# Towards an off-grid fecal sludge treatment unit: demonstrating energy positive thermal treatment [version 1; peer review: 2 approved, 2 approved with reservations]

# Open Peer Review

**Figure 1.** The Biogenic Refinery Combined Heat and Power system uses thermal energy produced through the thermal treatment of feedstocks to generate electrical power using an organic Rankine cycle generator (black dashed box).

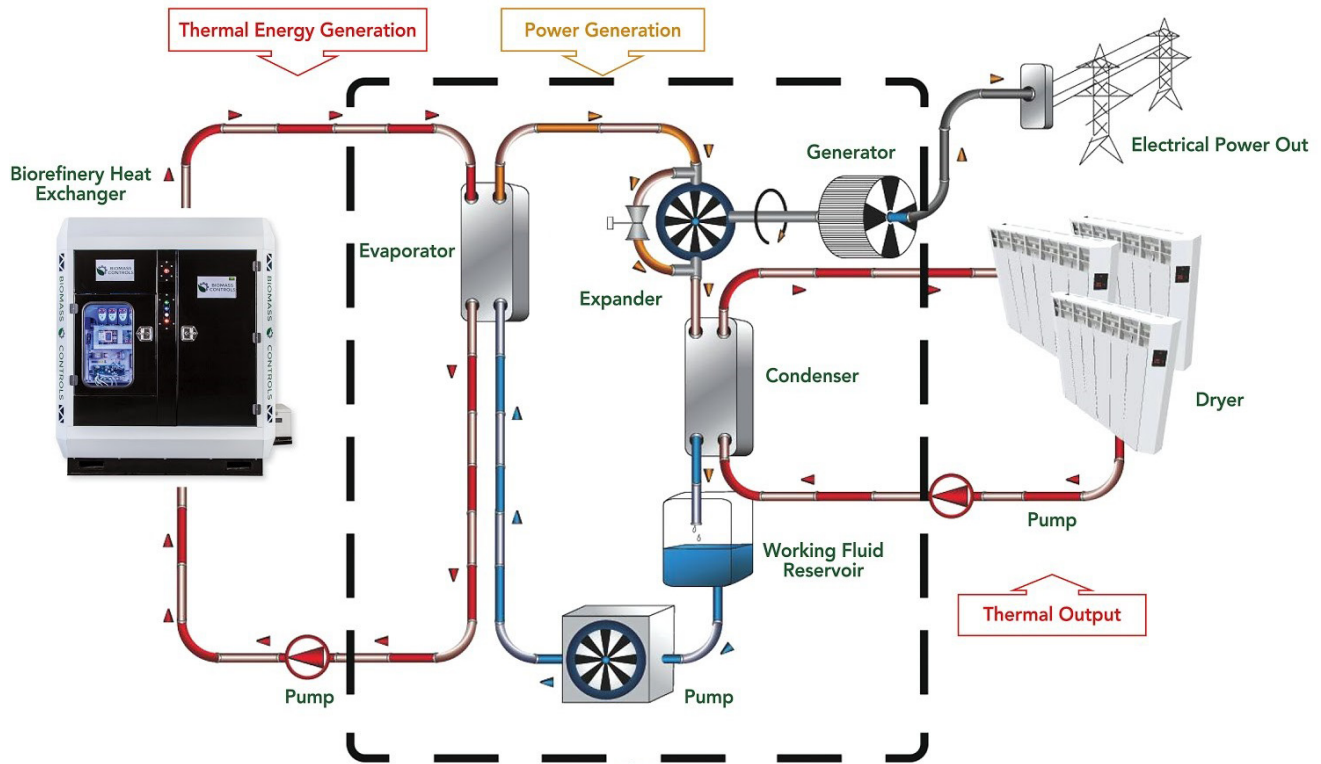
- I find the description of the operation of the system to be very confusing and Figure 1 does not clarify the system sufficiently. Where on Figure 1 is the pyrolysis/combustion occurring? Where are the stack gases directed? Do they go through the oil heat exchanger first, and then through the hydronic system? The authors should label each working fluid in the loops on the diagram. In addition, I do not see the hydronic heat exchanger module on the figure. What are the "Dryers" on the figure?
- The authors should state typical pressure and temperature values in their work of the oil, water, and ORC working fluids.

- The sentence “During steady-state operation, water, oil and air temperatures of gases” does not make sense to me. Can the authors clarify? The authors should label the location of each thermocouple/thermistor on Fig. 1.
- “Although thermal energy is provided by the BR for drying incoming feedstock”: Is the feedstock dried to lower than 35% moisture content? If so, how low?

- Figure 1: The captions of figures are conventionally written without any conjugated verbs.
  - Section “Feedstock”, paragraph 2, first sentence: The moisture content of 35% is too low to be from a raw faecal sludge. So, I think that you are referring to previously dewatered or dried sludge. You have to specify this.

**Figure 2.** A Sankey diagram of energy flow of the Biogenic Refinery Combined Heat and Power unit during steady-state operation.

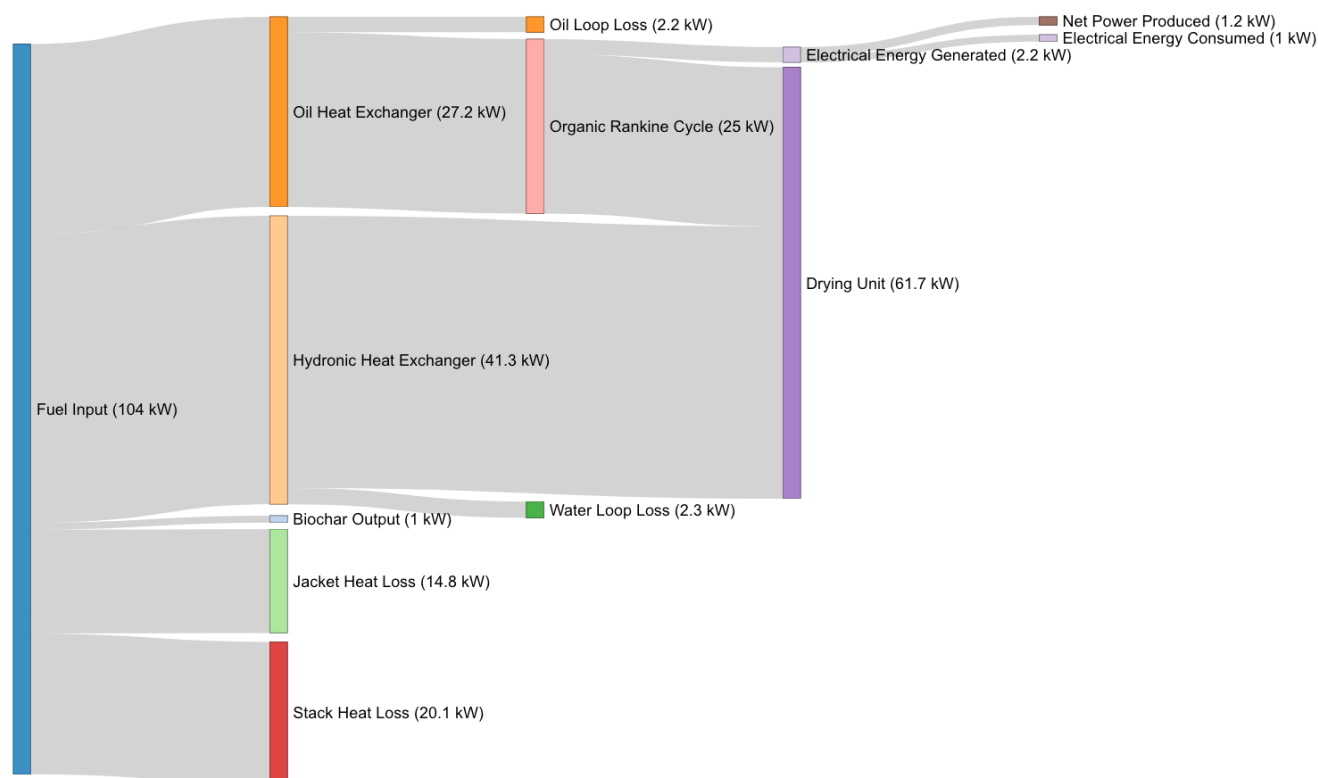
- The Sankey diagram in Fig. 2 includes electrical energy output, but the authors stated that the ORC was taken out of the loop for the thermal power balance test. This seems inconsistent and the authors should please clarify. The authors note in the text that the fuel input power is 104.5 kW but only show 104 kW on the diagram, although other numbers are specified to one decimal place. The authors should be consistent.

- What information is present in this table and figure that isn't present in Fig. 2?

**Figure 4.** Electrical power balance of the Organic Rankine Cycle.

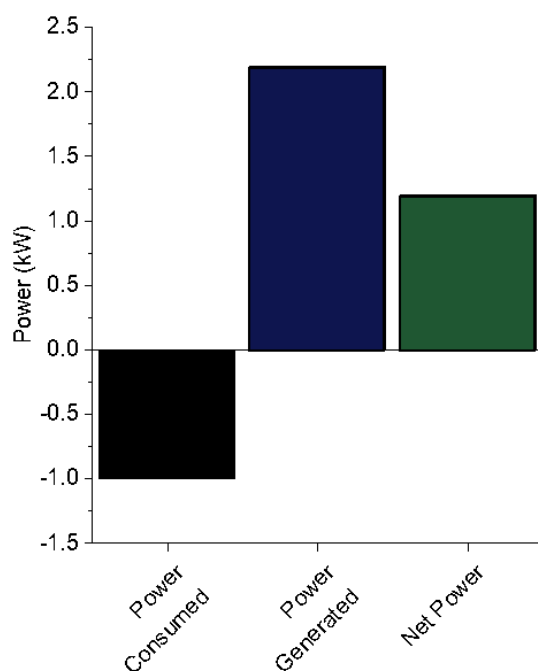
- How is the power draw of the system calculated? Does it include all the fans, pumps, electronics, and other accessories necessary to run the system, including the oil, water, and working fluid pumps? I don't think that Fig. 4 adds anything to the manuscript and could be removed.
